DATE OF BULLETIN:

10-17-2017

MODELS AFFECTED:

PILOT-HD GTX XR

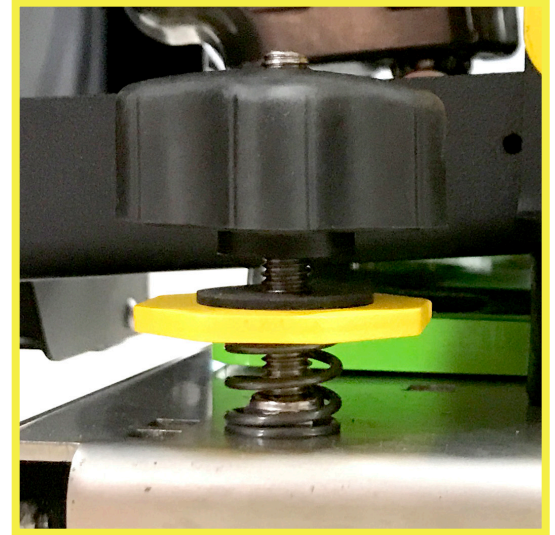
Shroud Wipers moving out of adjustment over time

Spring underneath Shroud Adjustment Knob

Rubber Washer on top of Shroud Adjustment Knob

All Disk Rider Scrubbers include new Rubber Washer (Part #: H-4440040) and Support Spring (Part #: 4-386) surrounding the Shroud Adjustment Knob. The Spring that is supported by the Deck, ensures that the Adjustment Knob will not self adjust down over time from machine usage. The Rubber Washer that now sits on top of the Adjustment Knob is to reduce rattle with the machine in operation.
